Washington State Convention Center Addition Project

Design Review Board Design Recommendation Meeting 01
05-03-2016

PROPERTY ADDRESS	SITE A 1600 9th Avenue
SDCI PROJECT #	3020176

2 EDG 03 COMMENT
SUMMARY

PINE ST ELEVATION

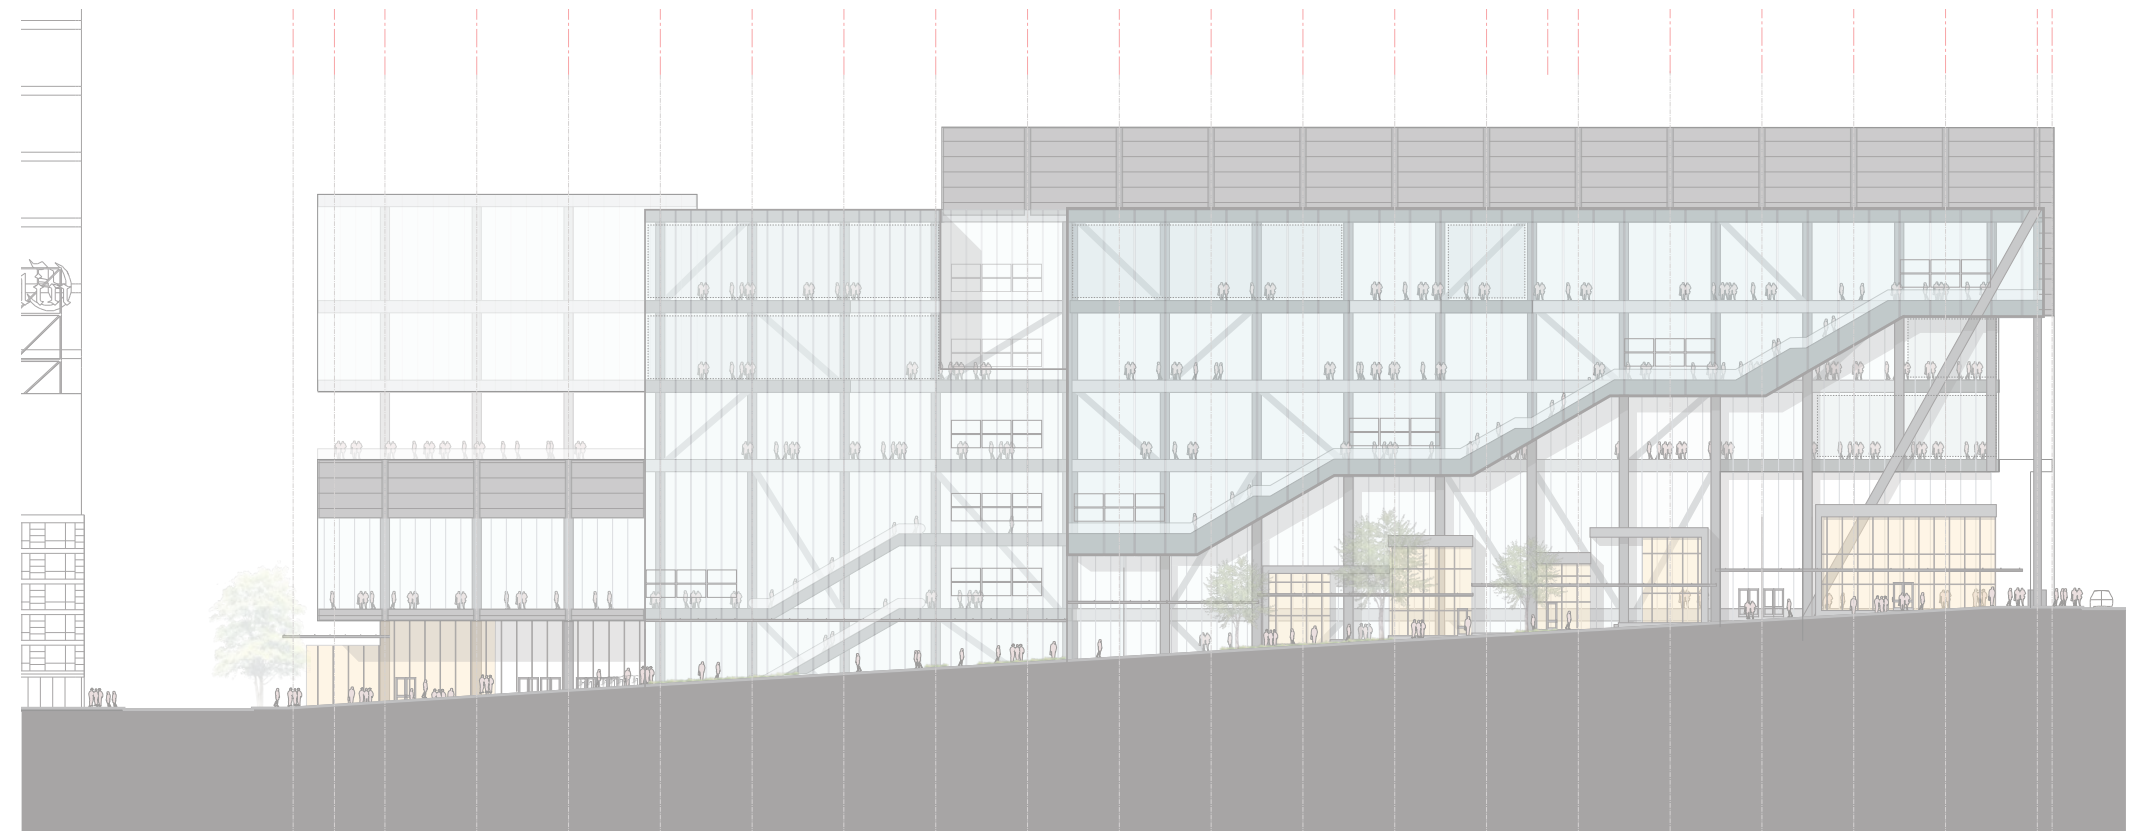
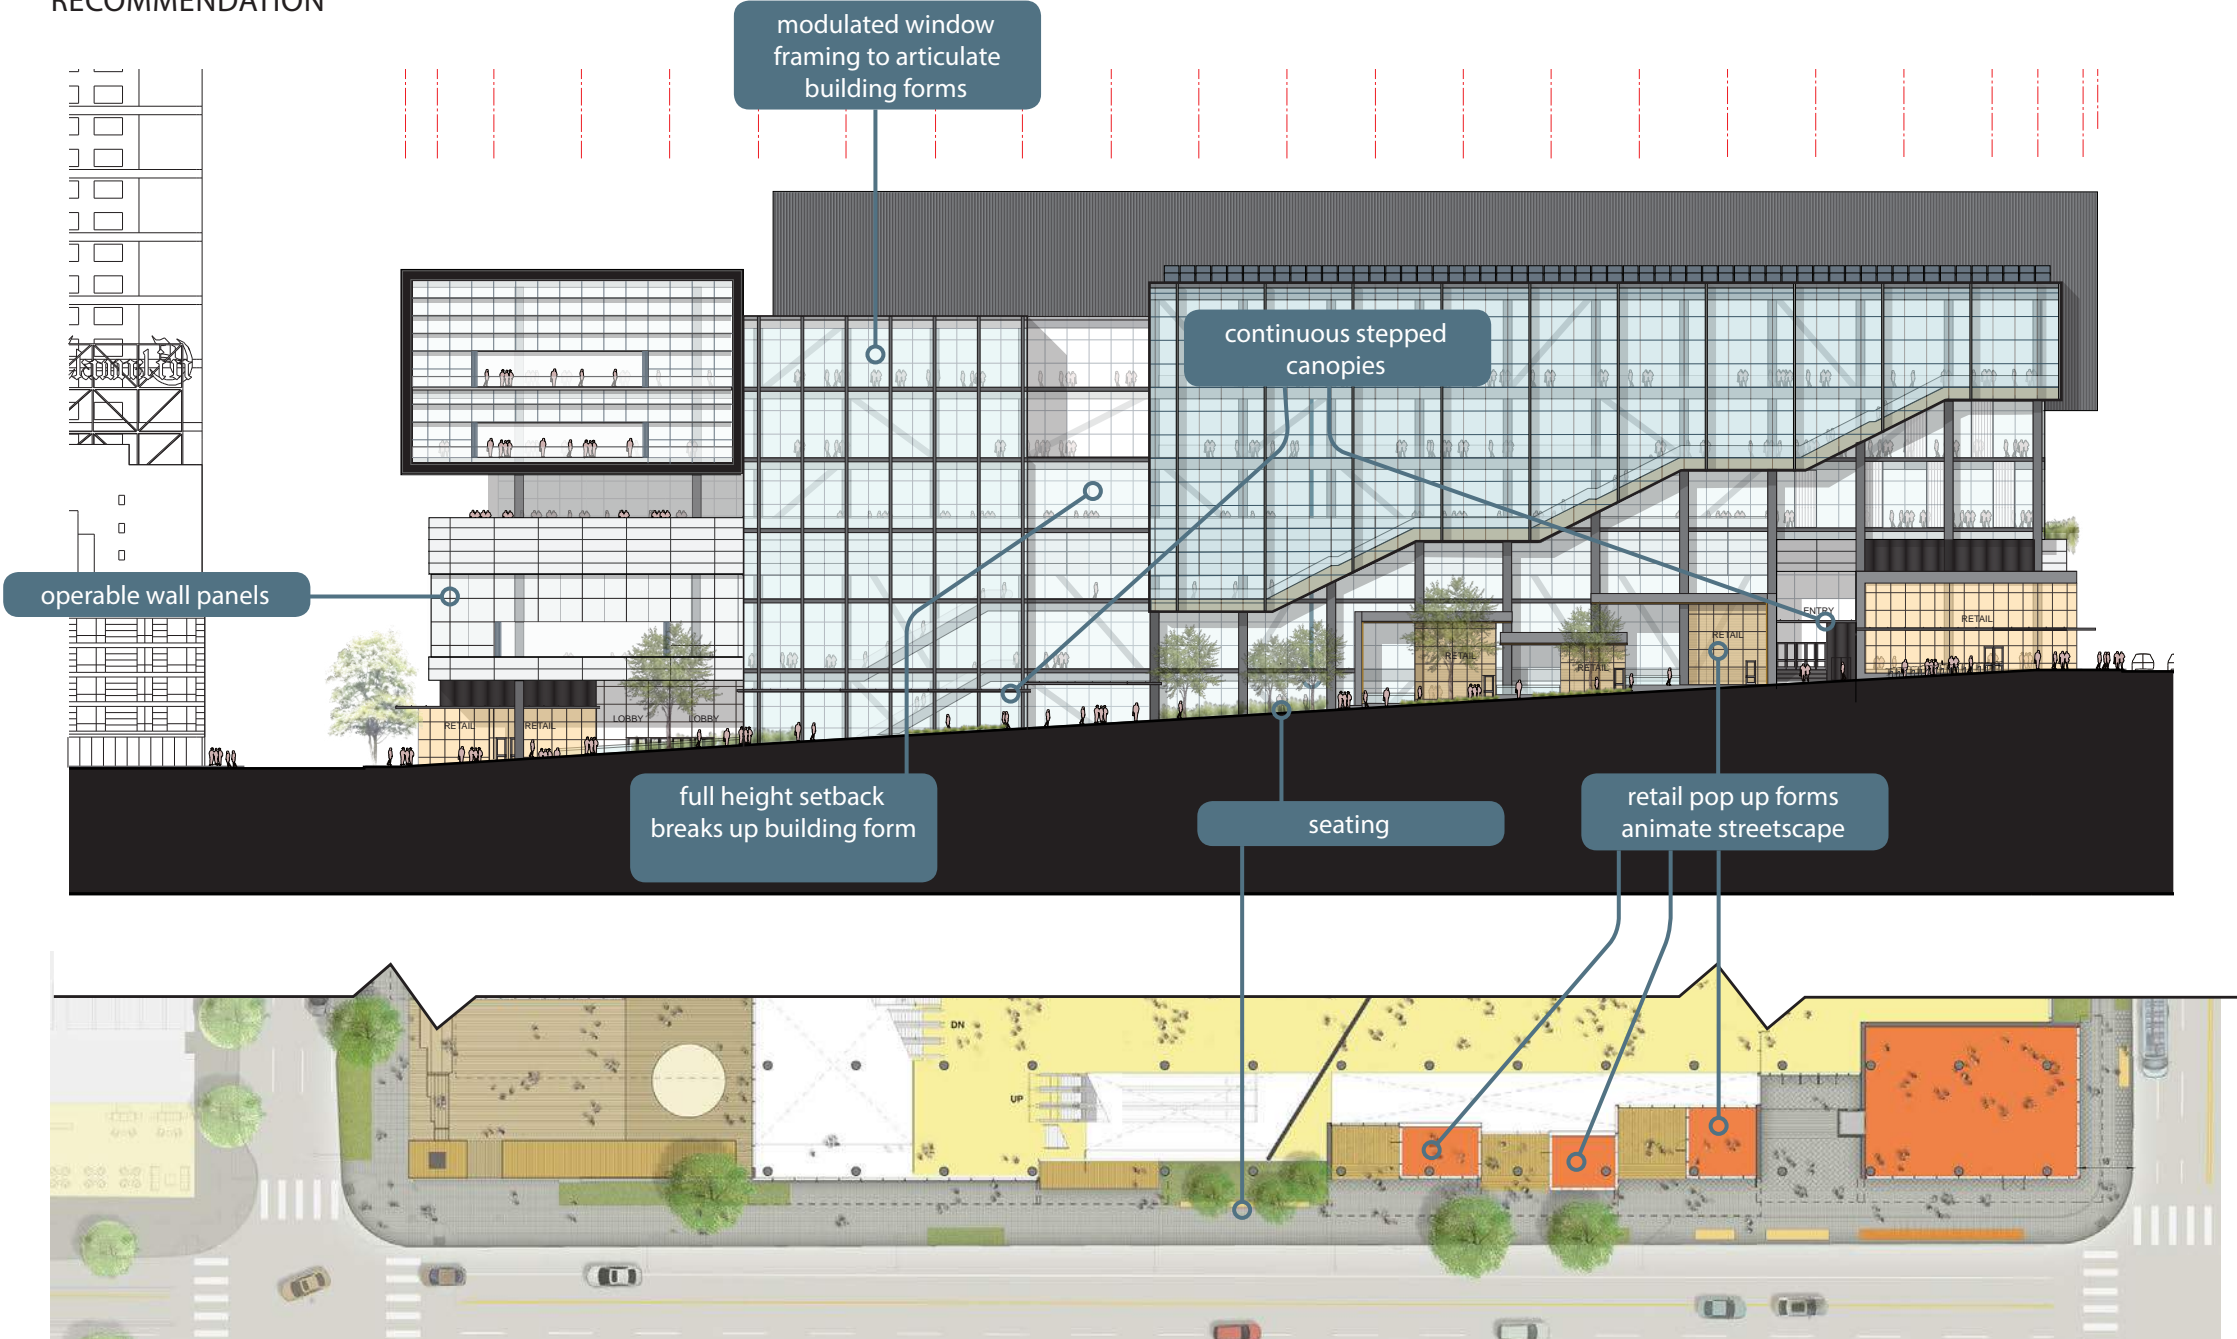
At the EDG#3, the Board again applauded the large models and restated the Pine Street elevation is highly visible, but agreed that the projecting stair form is effective at breaking up the previous flatness, and becoming a memorable, 'signature' for the CCX. It should be treated as a distinct sculptural move, possibly by adding a unique texture to the stairs south glazing layer, and/or emphasizing a dramatic soffit color/material. The Board was not convinced that soffit should be mirrored, but agreed this southeast facing elevation should remain bright and well-lit on all evenings (not only during events)

RESPONSE - The projecting stair form creates a unique sculptural element along Pine Street. External supports create visual interest and texture, while adding further definition to its unique shape. Clear glass provides optimum visibility inside and out, emphasizing the cascading ribbon of circulation and seating terraces within. The soffit provides additional interest at street level below, animated with reflections of the city and illumination spilling out from the adjacent glazing.

PINE ST ELEVATION

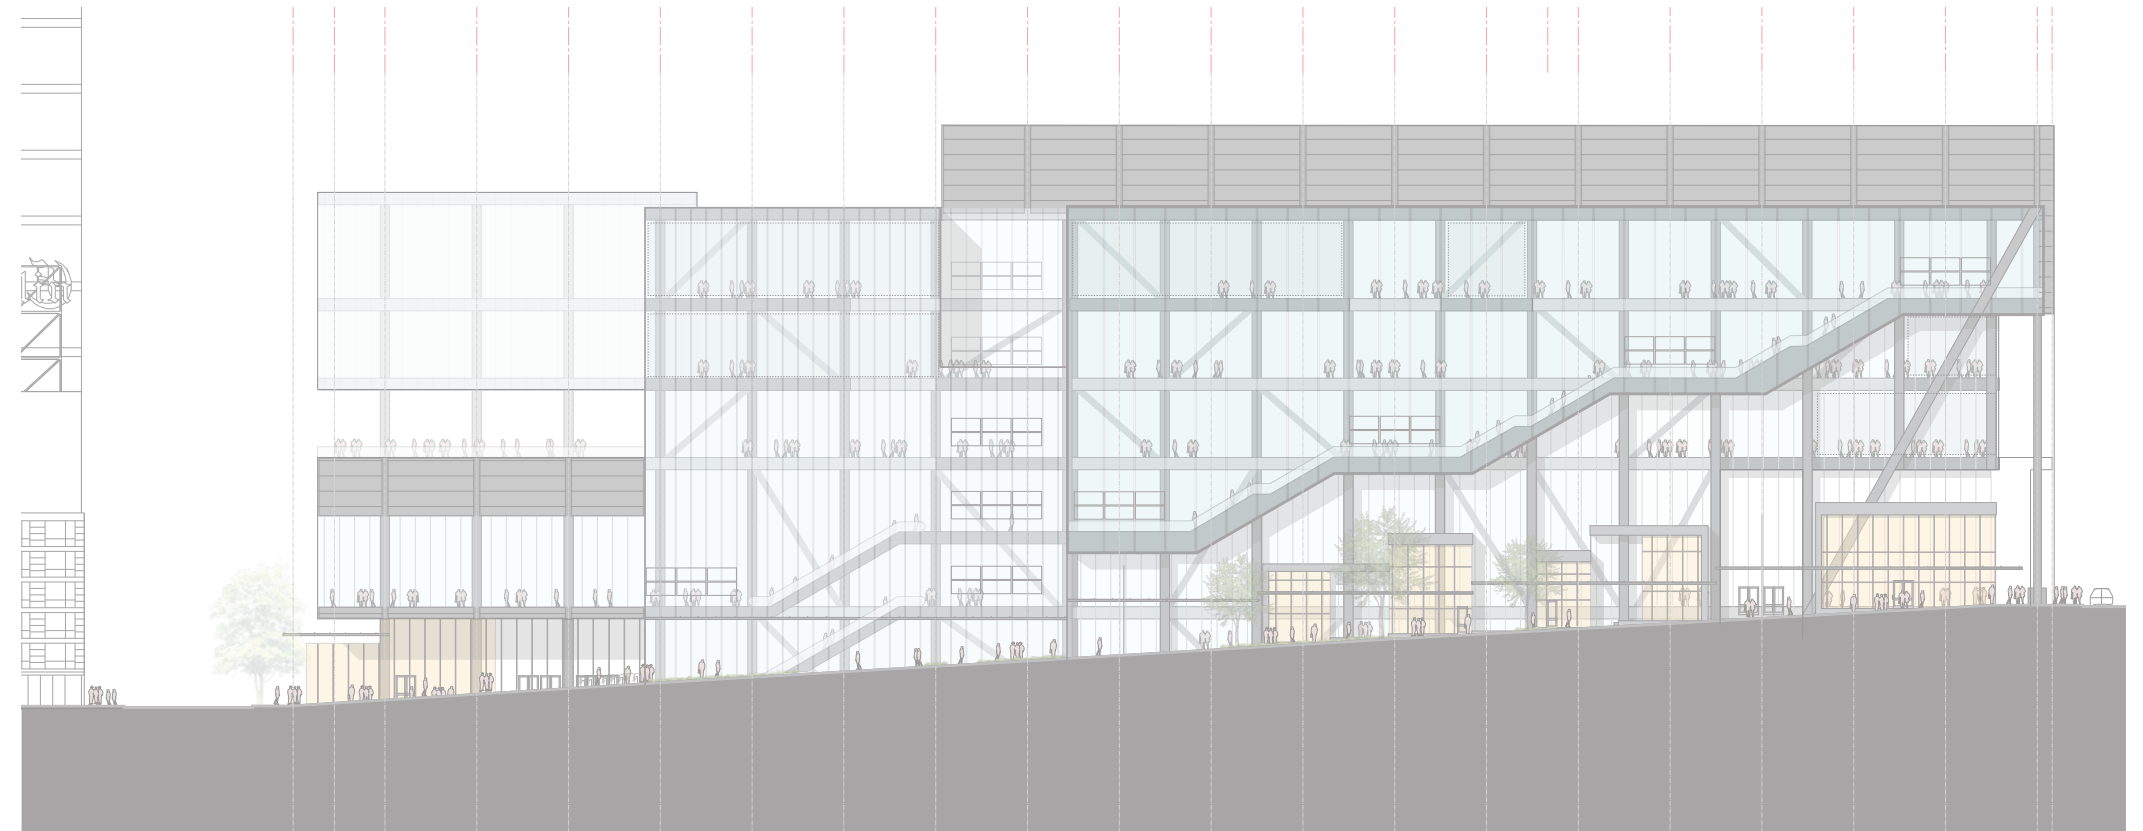
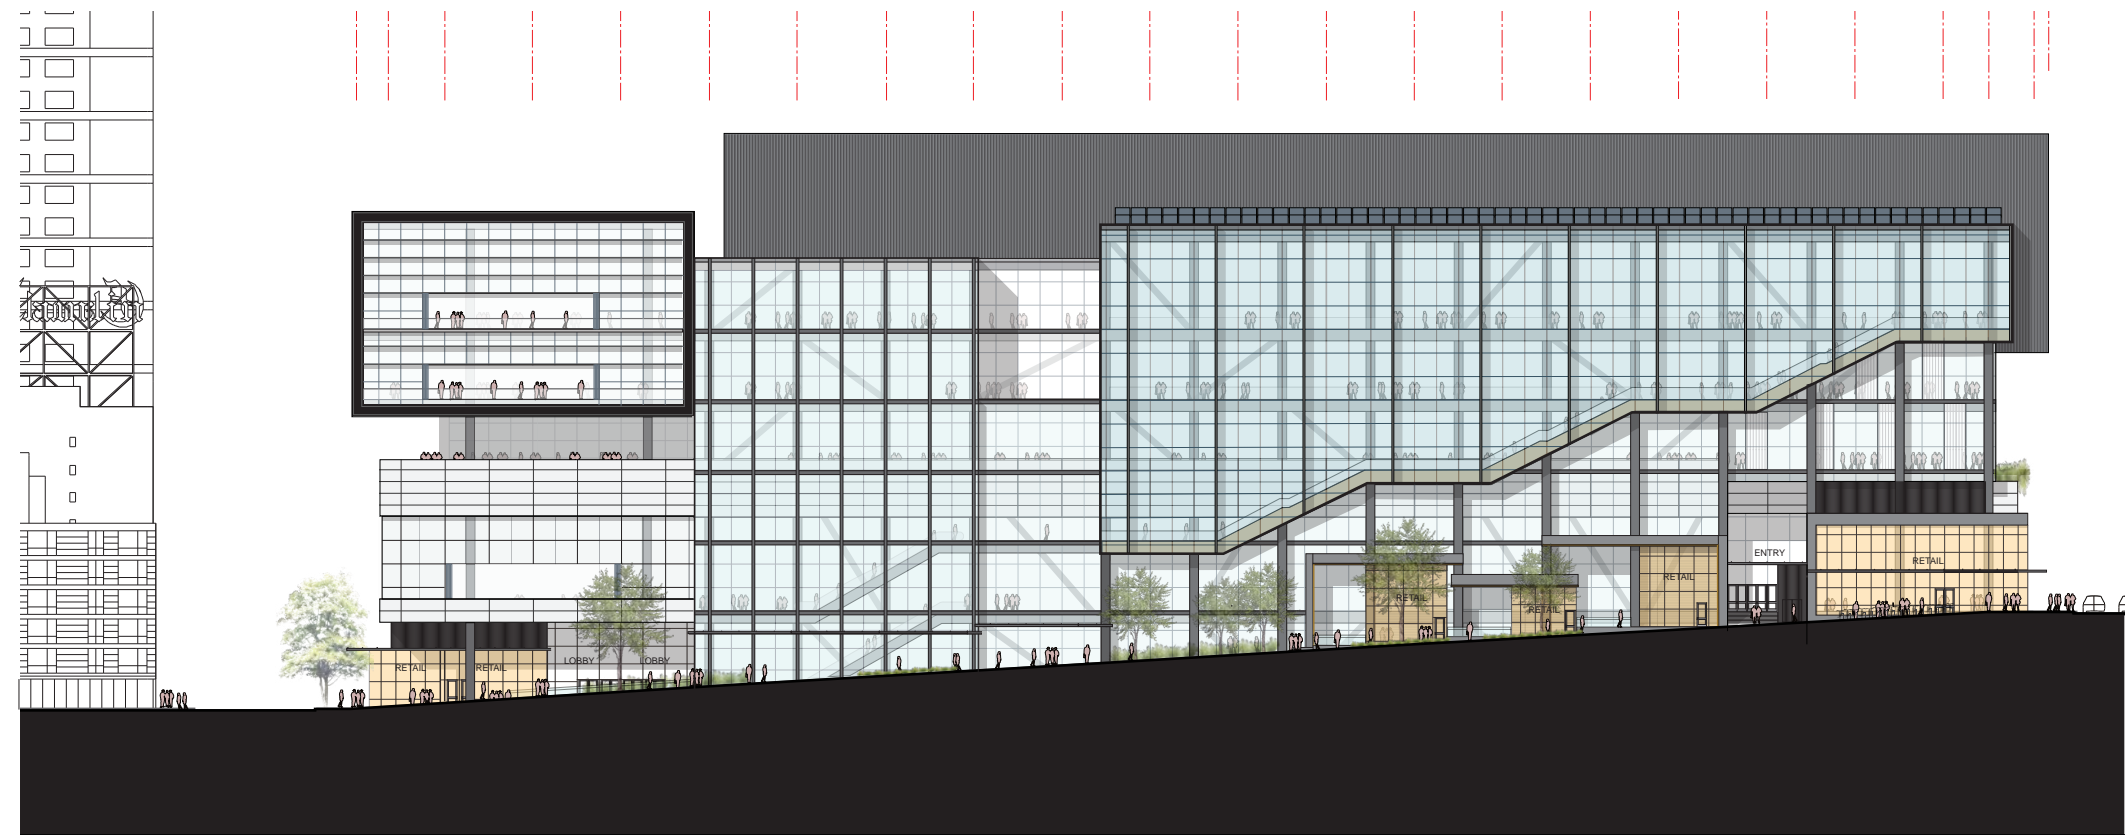
At the EDG#3, the Board strongly reiterated that it is critical to provide a strong and consistent pedestrian link between Capitol Hill and 9th by activating the street with a continuous edge of retail or other elements that provide pedestrian interest. The Board supported the building jogs and setbacks shown on pg 34 & 36, but was concerned about the approximately 130 ft long 'vacant space' between the west retail box and plaza on pg 36. The Board recommended the two-bay green recess remain, but incorporate seating that allows pedestrians to look down into the prefunction spaces, while retaining some green relief. The Board also recommended all four bays of glass adjacent to the escalators incorporate elements of scale and visual interest, possibly integrated with a kinetic interior artwork or other feature to stimulate pedestrians; the Board did not consider escalators to qualify for that, but the floating stair shown next to the windows is preferred to escalators.

RESPONSE - The west half of the Pine Street elevation has been further activated through the addition of a seating area extending the planting recess to the west. A large vertical floor opening at the building face exposes more of the drama and activity of the interior to the public. Additional planting has also been introduced along the south edge of the plaza extending past the building, providing a greater variety of textures and experience for pedestrians.
